**Applicant:** BEN MULLINS  
**Request:** BUILDING PERMIT  
**Meeting Date:** 4/11/2022

**Comments:** The applicant is requesting approval of a self-storage facility on Lovell Road in the PC (Planned Commercial) / TO (Technology Overlay) zones. Per Section 5.33.13 of the Knox County Zoning Ordinance, applications in the PC zone require approval through the use on review process, and the application is on the April 14, 2022 meeting agenda.

**SITE LAYOUT PLAN**  
 1-A 22-TOB-STORAGE LOVELL ROAD  
 KNOXVILLE, TENNESSEE

Slope Analysis  
Cases: 1-A-22-TOB

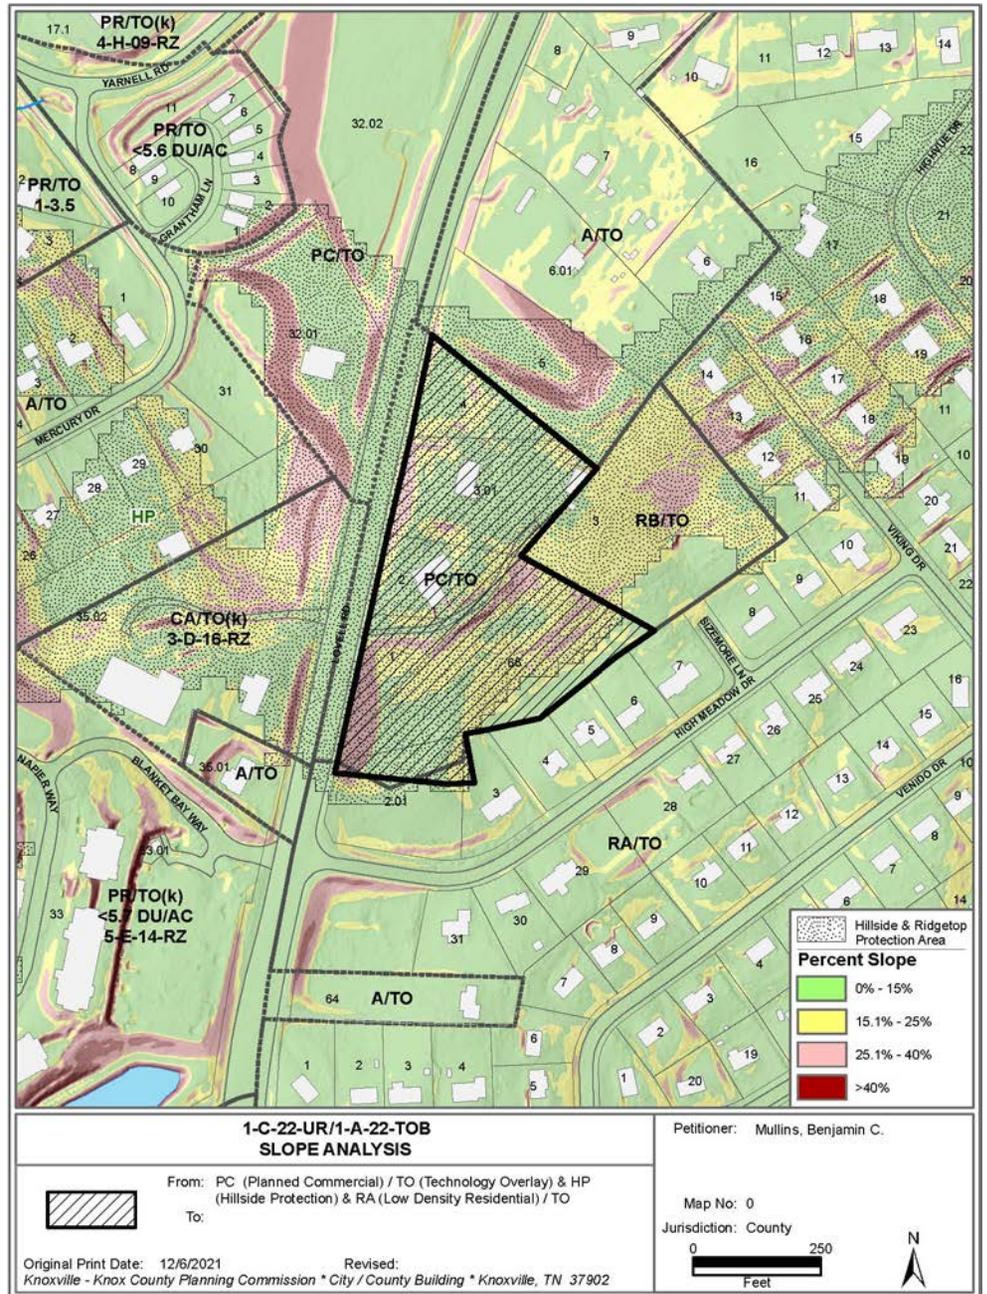
- 1) Site Acreage. According to KGIS, the site is 6.41 acres, and the slope analysis and all calculations are based on that acreage. The application states that there are 7.77 acres, so there is a discrepancy between the two measurements, though this does not affect the overall recommendation.
- 2) Multiple-Parcel Site. The site consists of several properties on the east side of Lovell Road south of Bob Gray Road. The properties would need to be platted and combined into one property since some of the proposed structures cross over property lines. The applicant has stated that a plat would be forthcoming; this would be required prior to permitting so that the setbacks would be met.
- 3) Overall Layout. The proposed plans include four buildings spread out over the property with

10) Disturbable Area. The maximum disturbable area recommended by the slope analysis is 4.2 acres. The site plan proposes to disturb 4.18 acres.

# Exhibit A. Site Plan Superimposed over Slope Map

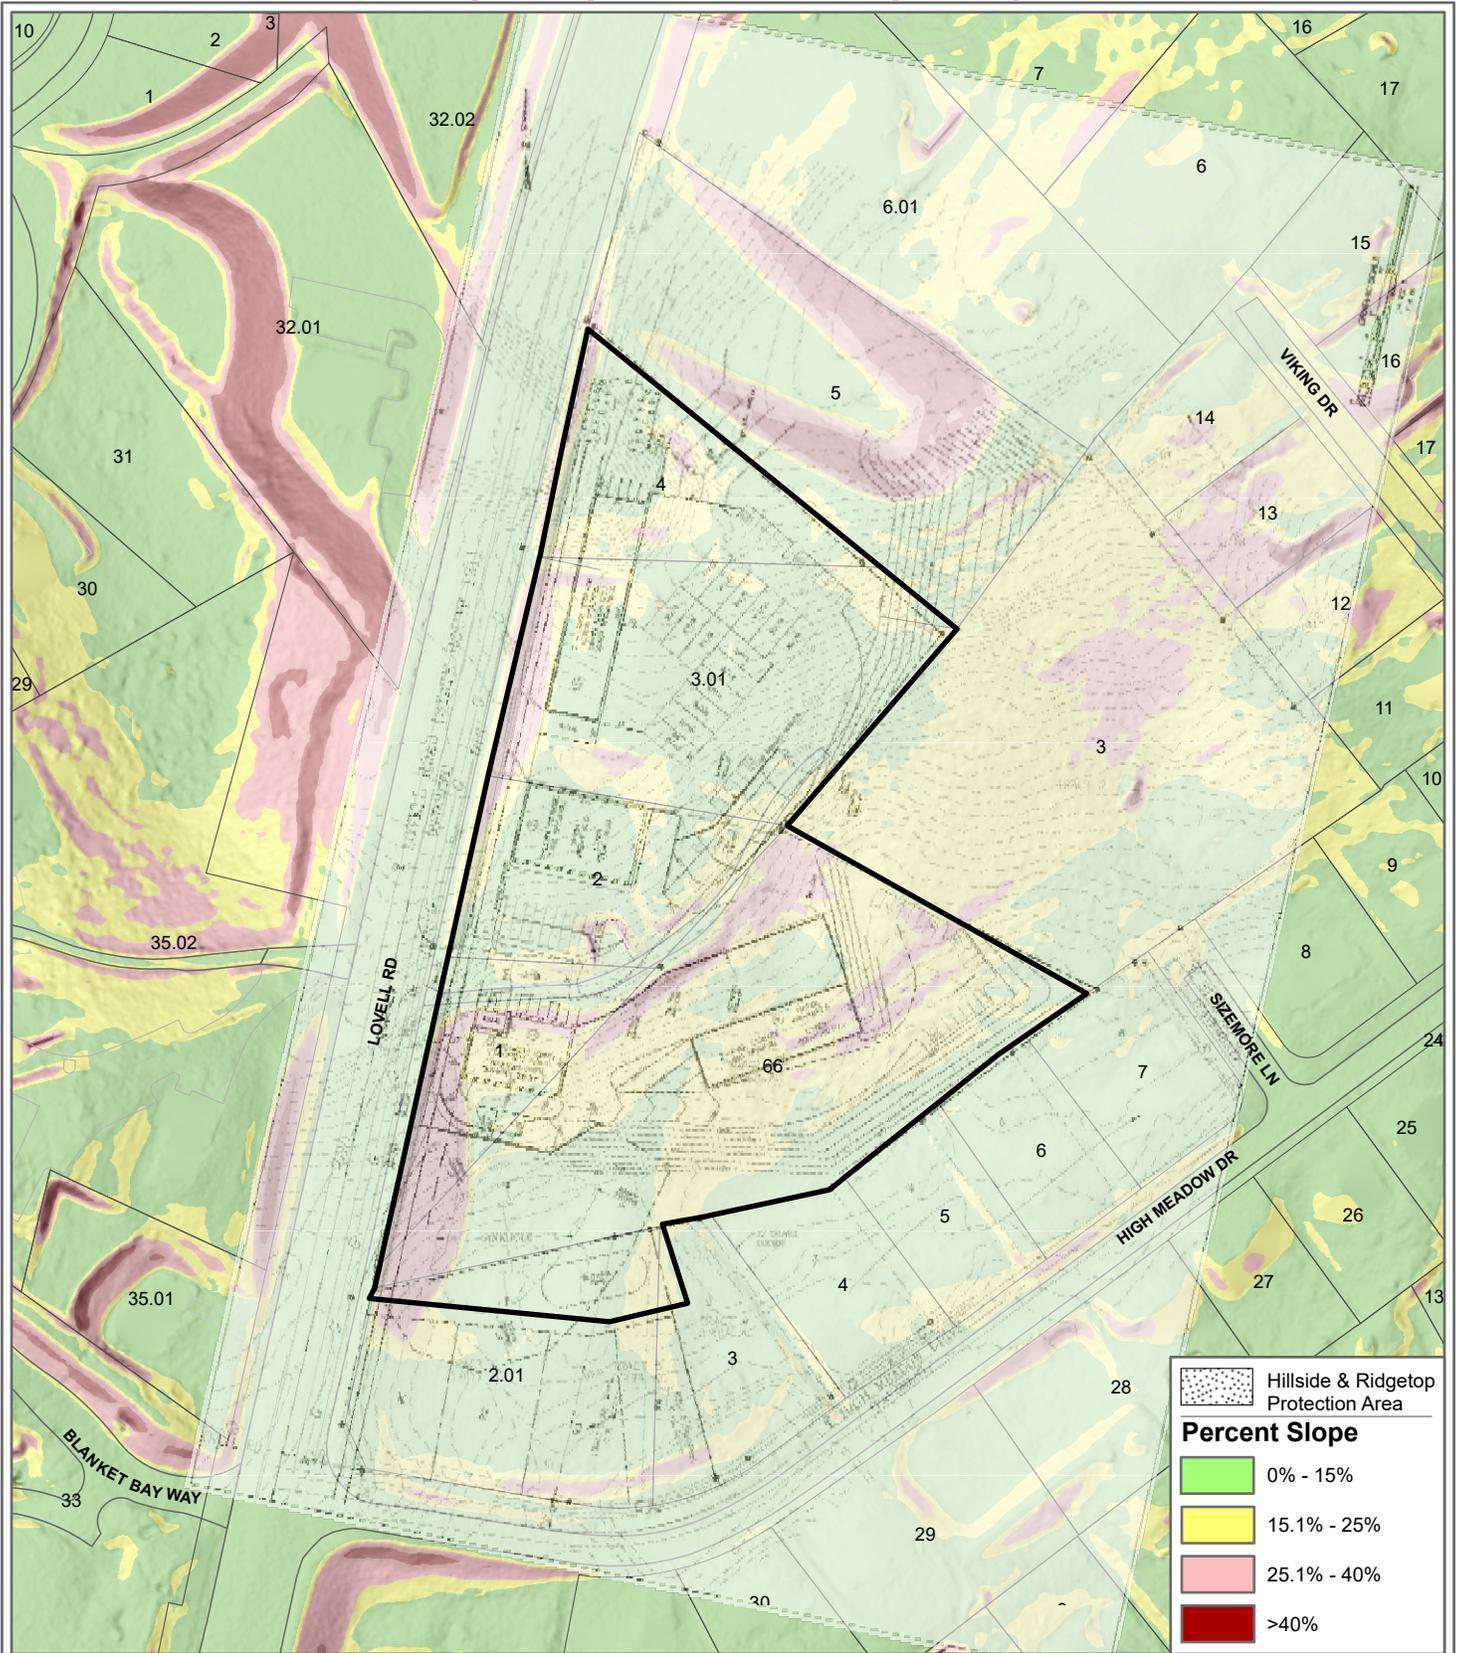
c) IAR. In HP areas, the proposed Impervious Area Ratio (IAR) is not to exceed 50% on slopes ranging from 15% to 25% (land disturbance is prohibited and land conservation is to be 100% retained on slopes over 25%). Since he is requesting waivers from the IAR and the slope conservation requirements, the applicant has not provided any statistics on development within any of the slope ranges over 25%, so staff cannot determine the proposed IAR ratio in the prescribed sloped areas. However, georeferencing the plans into the slope map demonstrates where buildings are proposed in slopes ranging from 15-25% (see exhibit A).

12) Slope Conservation. Land disturbance is prohibited in areas with a slope greater than 25%, as is grading for parking lots on land with natural slopes of 25% or greater. The georeferenced site plan on the slope map shows that parking lots and grading are proposed on land with slopes over 25%.

**PLANTING PLAN  
ENLARGEMENT**

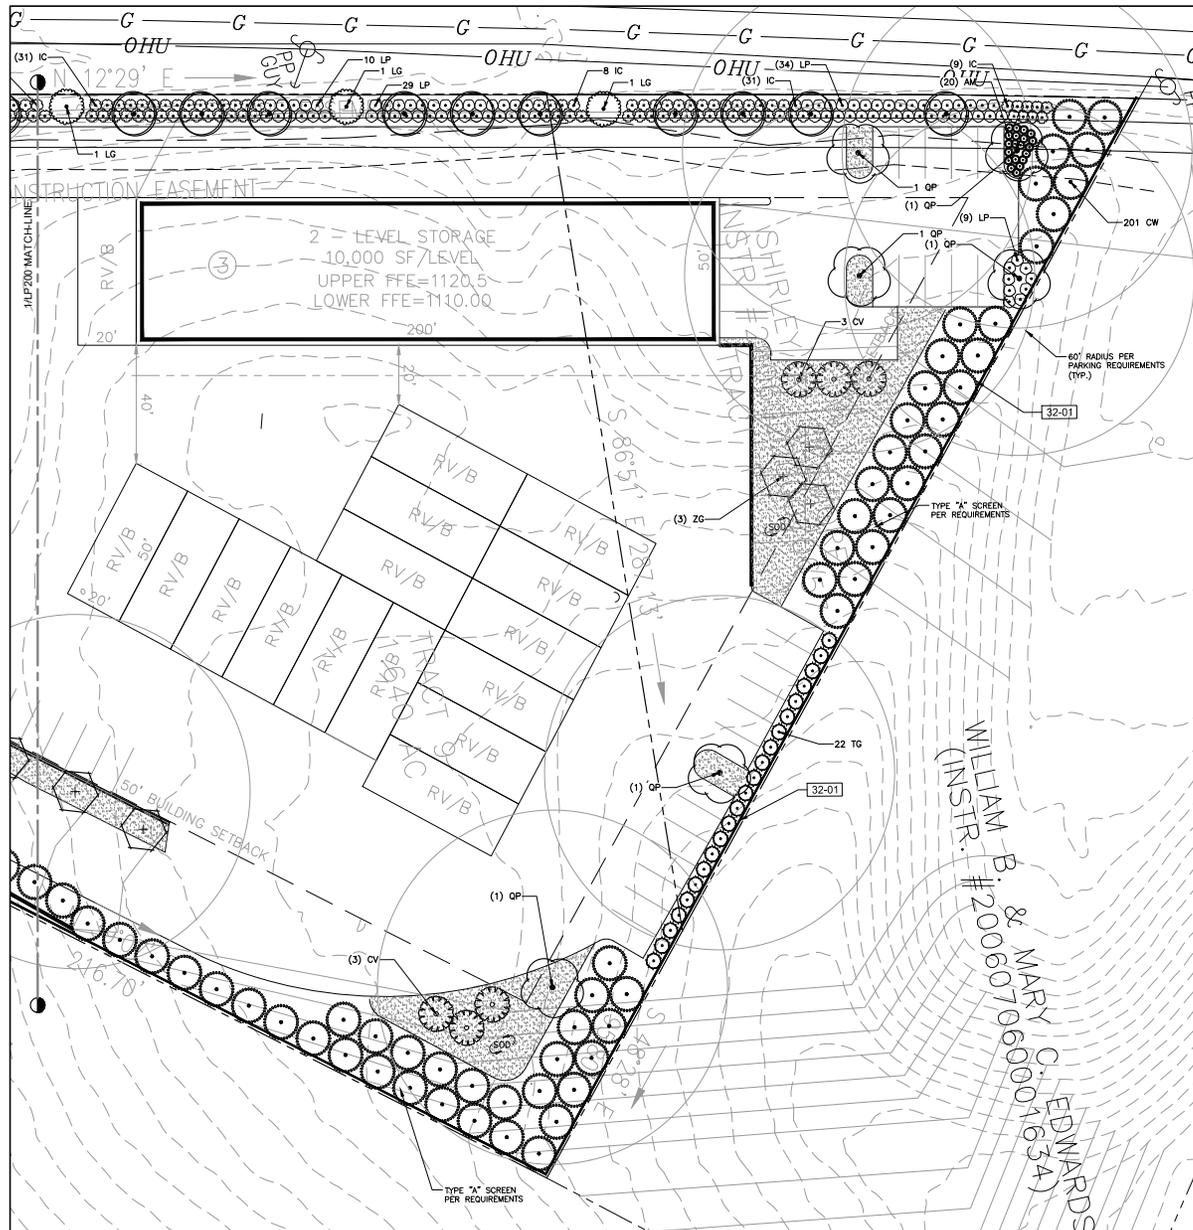
22) Landscaping. The landscaping plans meet the TTCDA Guidelines. Staff requested supplementing the originally proposed landscape screening at the ROW with evergreen trees to screen the metal buildings and loading doors from the ROW during the winter months. The current proposal utilizes 20 deciduous trees and 5 evergreen trees along the 883-ft frontage. Staff recommends additional evergreen trees to provide more screening.

- 16.) The landscaping plans have been submitted and tried to address the buffering but may request a waiver to ensure this issue has been addressed

SITE LIGHTING PLAN

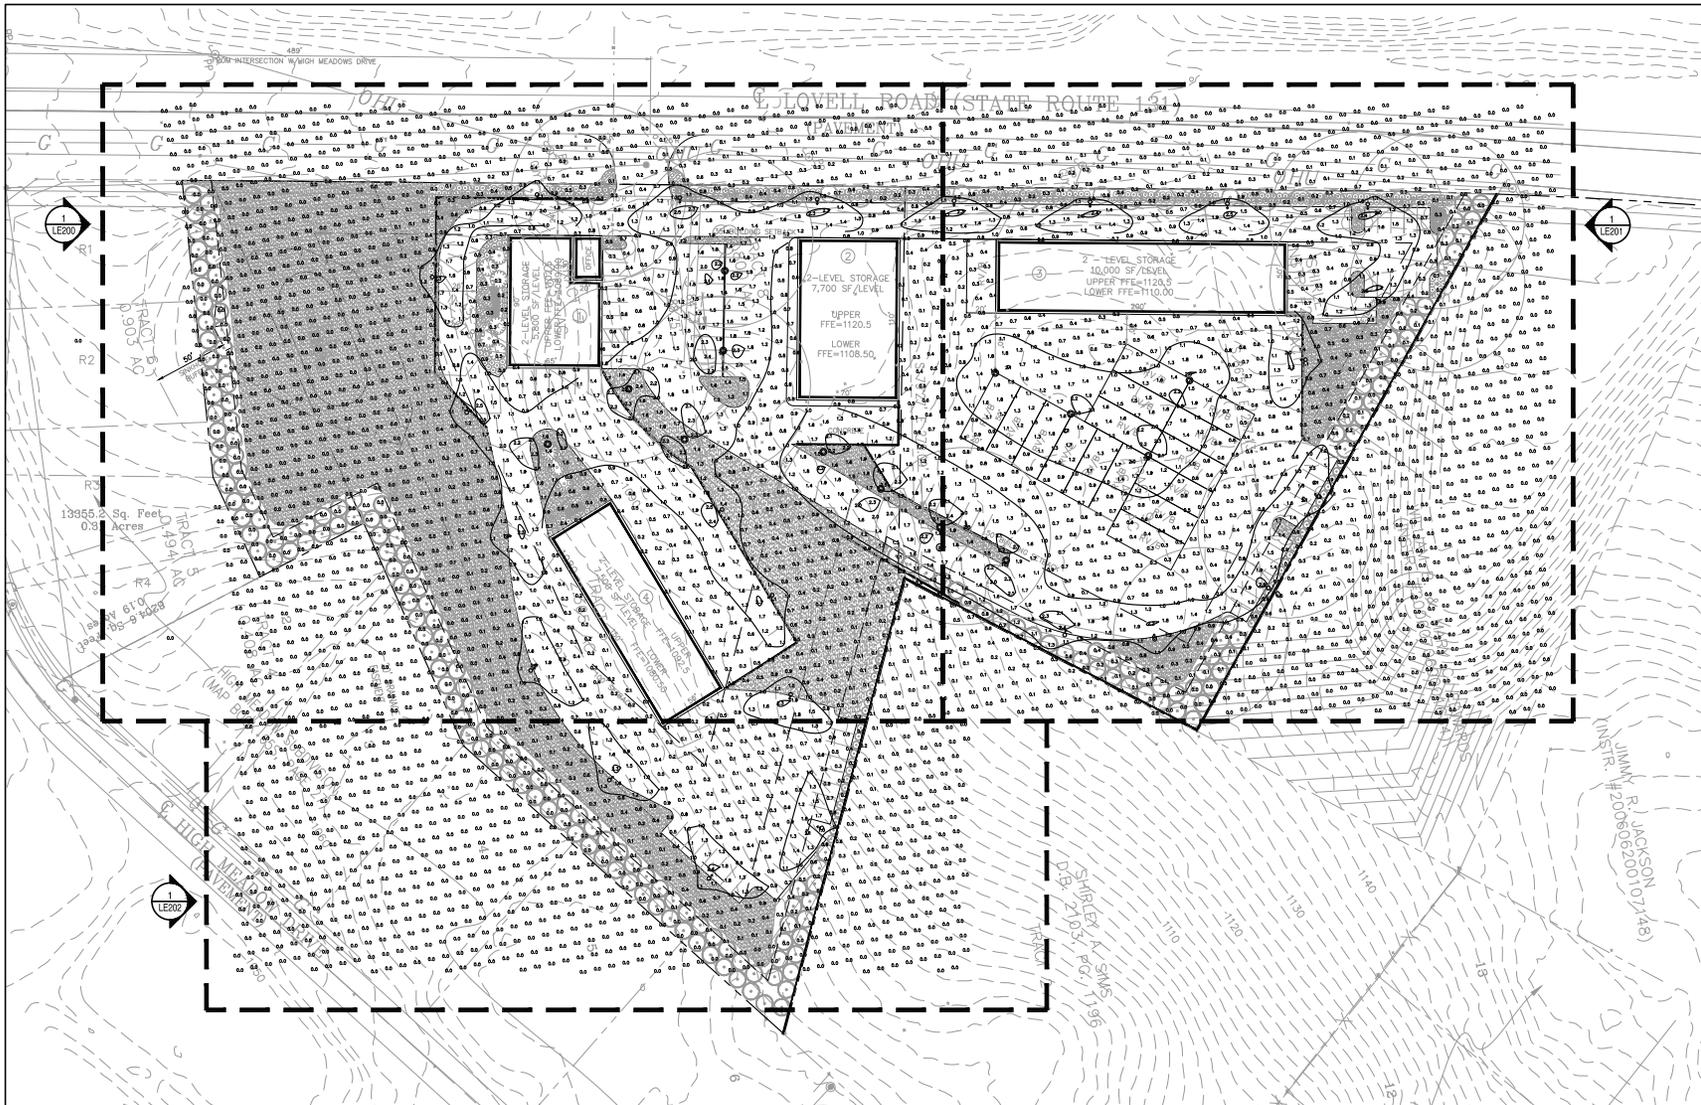
24) Lighting levels exceed the maximum footcandles (fc) allowed along shared lot lines with other zoning, and the lighting plans will require two waivers as described below. The applicant has stated that the photometric plan does not take the tree buffer or 8-ft wooden fence into account in the calculations. Therefore, the actual light level at the lot line will be less than what is shown on the plans, and staff supports approval of this waiver.

a) Waiver of Section 1.8.5(E) requirements to allow 1.8 fc within 20 ft of a residential zone (versus the 0.2 maximum allowed in the Guidelines).

The fc in the parking area next to building 3 shows up to 3.5 fc, which exceeds the 2.5 fc allowed in parking areas. A waiver will be needed to allow the overage. This is an area where the waivers are more flexible to allow light levels that exceed the fc, within reason, in order to provide additional safety on sites. You can cite that as your reasoning for requesting waivers for the site lighting in the parking areas.

***RESPONSE: The specified light fixture was changed to a fixture with a lower lumen output following the original round of comments. This lower lumen output reduced the highest footcandle reading on the plans from 3.5 fc to 2.5 fc, which is in compliance with Section 1.8.5.B.***

***RESPONSE: All light fixtures along the perimeter of the property are specified with a cutoff louver shield and are directed away from adjacent properties per County Zoning Ordinance, Section 4.93.01.E. and TTCDA Section 1.8.***
